## HISTORIC PRESERVATION REVIEW BOARD STAFF REPORT AND RECOMMENDATION

Property Address:	<b>2010 13<sup>th</sup> Street N.W.</b>	<b>X</b>	Agenda
Landmark/District:	<b>U Street Historic District</b>		Consent Calendar
Meeting Date:	<b>December 17, 2022</b>		Concept Review
H.P.A. Number:	<b>HP 23-092</b>	<b>X</b>	Alteration

Property owner Simon Kashi seeks concept review for construction of a basement entrance stair and areaway in the public space front yard.

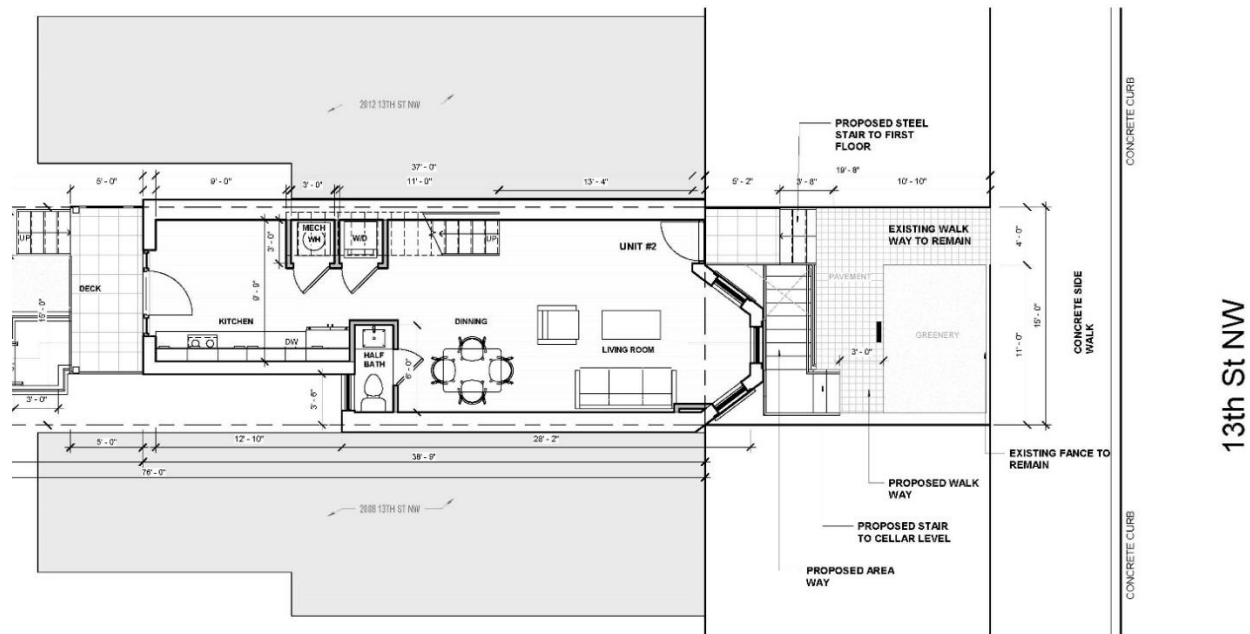
Basement areaways are not uncharacteristic of the U Street Historic District. On bay-front rowhouses, basement stairs almost uniformly run parallel and under the primary stairs and share the primary walkway rather than have a separate walk. Basement stairs that are accessed from the opposite side of the house as the front door and run across the front of the bay are neither

common nor compatible. In this instance, it would result in a majority of the front yard becoming paved and the house would visually appear set within a moat rather than on the ground. While this row features a basement entrance at the end unit, it was installed prior to the historic district and looks significantly different from its neighboring contributing properties.

The applicant previously proposed an areaway stair that ran parallel to the existing walk and front stair, as is more typical in form and orientation for the historic district. However, the stair projected further out (8 feet) than is permitted by the public space regulations (7 feet) and also resulted in the need for continuous guard railings on each side of the stair due to its depth.

*HPO recommends that the Board not approve the concept as proposed as it is not compatible with areaways in the U Street Historic District.*
